**Report on the Assessment of
Development Application No. 241/04
Pursuant to Section 80 of the Environmental Planning
and Assessment Act, 1979**

**Proposal by RES Southern Cross to build a wind farm
at Taralga, in the Upper Lachlan Local Government
Area**

November 2005

Figure 1 Proposal layout and house locations

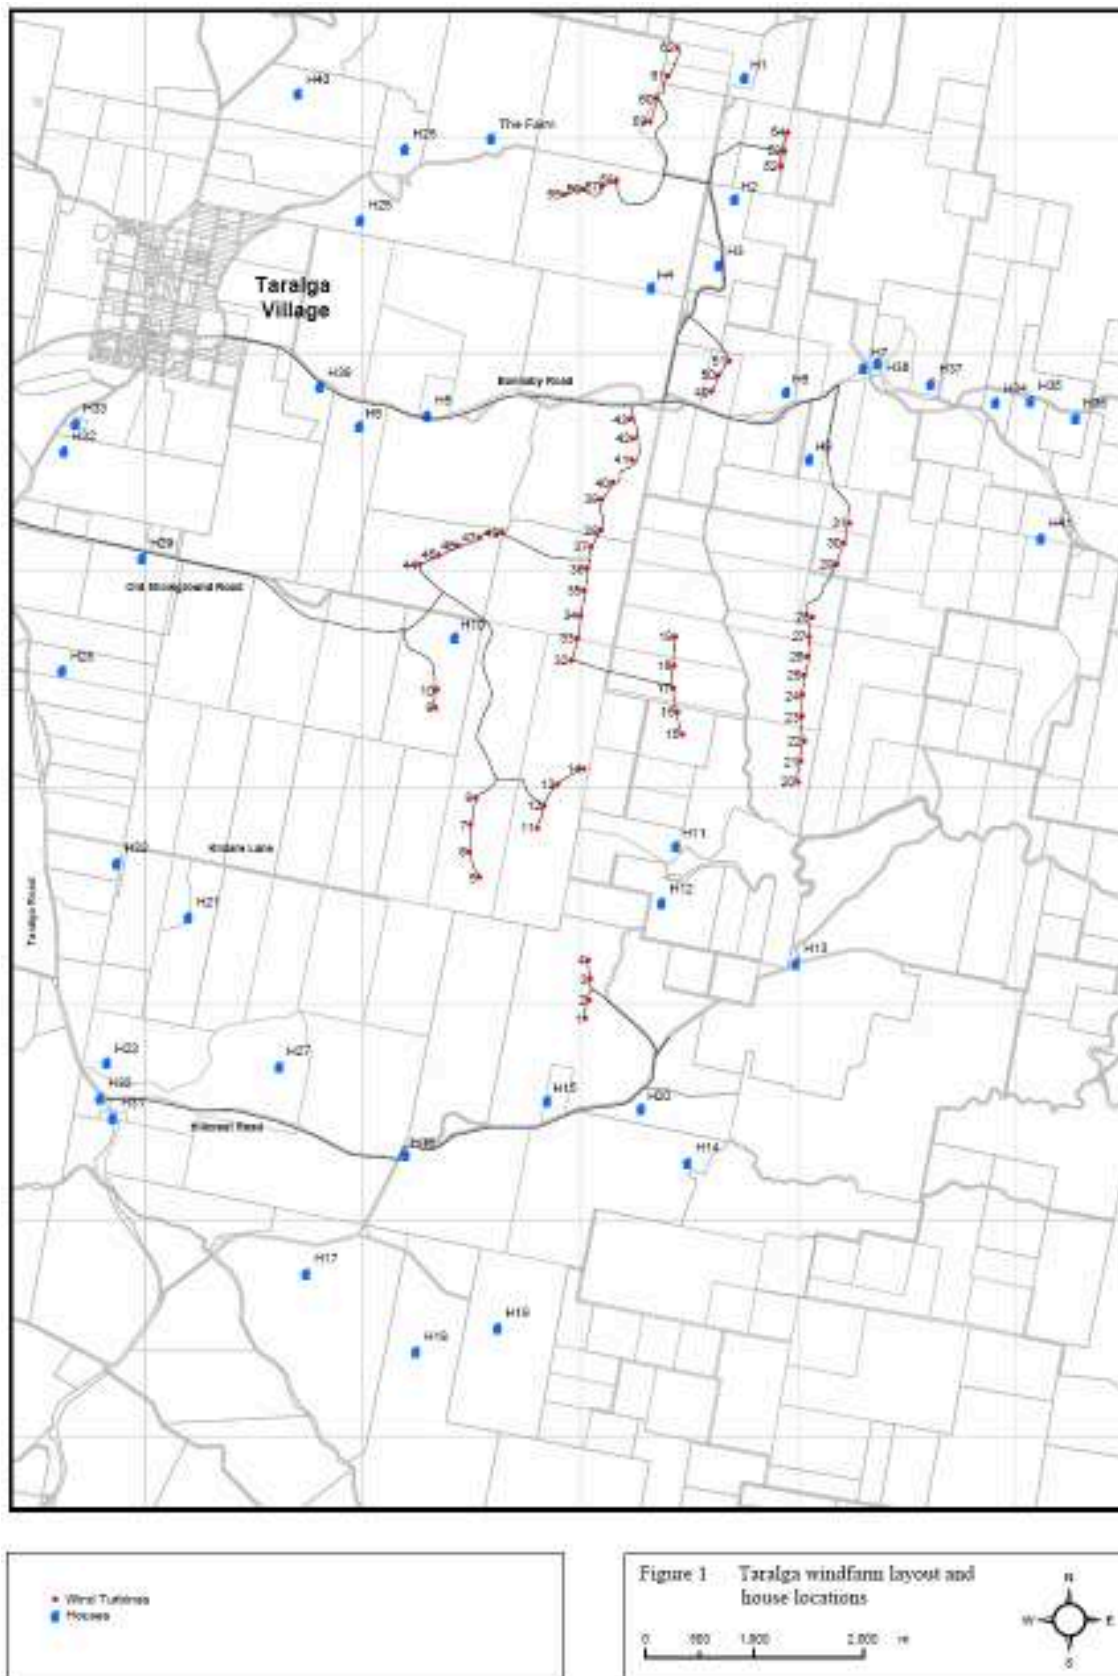
In recognition of the extent of concerns raised about visual impacts, the Applicant produced additional photomontages from four key residences (H3, H5, H12 and 'The Farm' – Figure 1) to further assess impacts. The Department considered that at least two of these properties could potentially be severely visually affected by the proposed development (H3 and H12). The other two residences were nominated as they were considered to be potentially affected and representative of a number of other private viewpoints.

The report found that the visual impact on H3, H12 and 'the Farm' would be 'substantial'. The finding of substantial impact is driven by the large degree of visibility of the development on the horizontal plane and the proximity of the turbines. The visual impact at H5 was assessed as 'moderate'.

Figure 5 Relocation of turbines T5 to T8 as a result of 80 degree horizontal view angle

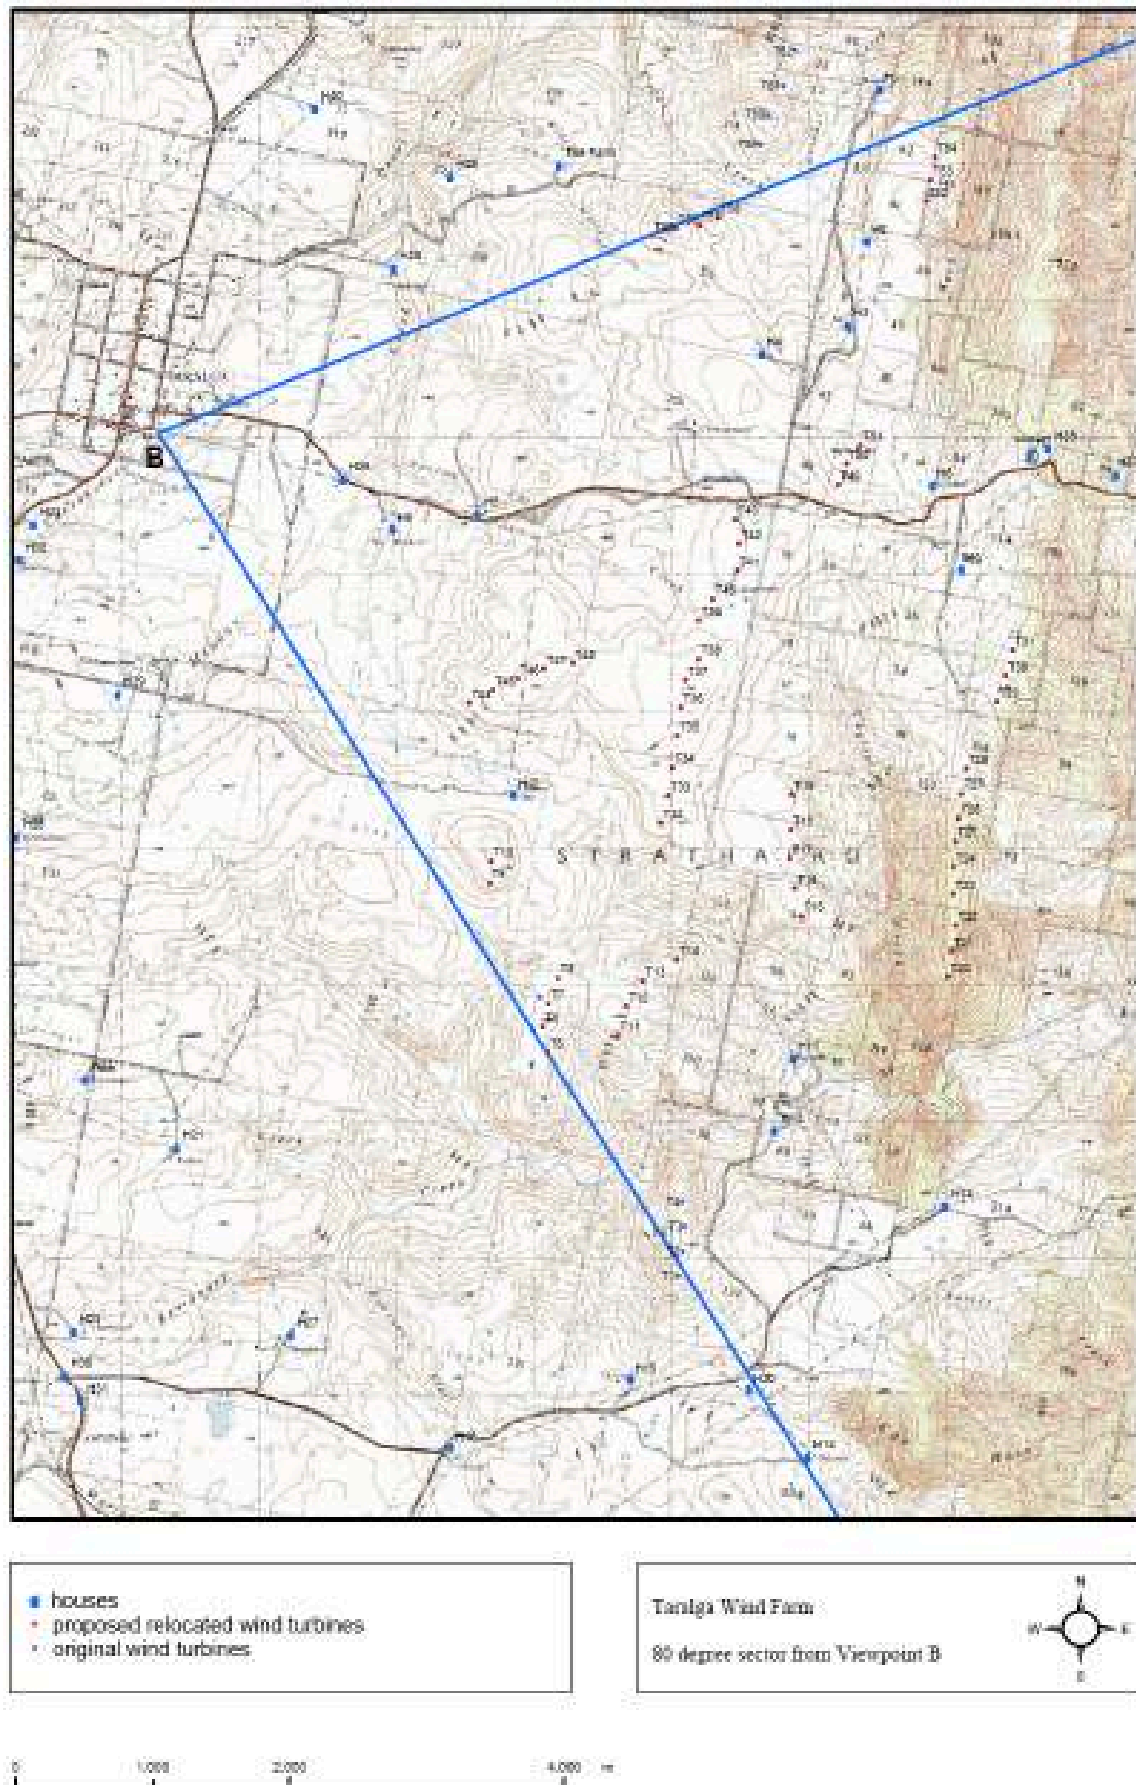
From consultations with the Applicant, and as shown on **Figure 4**, it was determined that the 80 degree angle from Viewpoint B could be most effectively (i.e. minimum reduction in turbines) achieved by:

- deleting the four northern most turbines (T59 to T62);
- relocating four turbines (T5 to T8) by up to 250m to the north east subject to a staged consent and supplementary environmental assessment – see **Figure 5** for revised locations;
- deleting the southern most turbine (T1).

- deletion of eight turbines (T1 to T5 and T59 to T62); and
- staged consent for four turbines (T5 to T8) subject to the proposed relocation of these turbines so that they are within the 80 degree horizontal view angle from Viewpoint B (see Figure 4) and further environmental assessment of key issues.
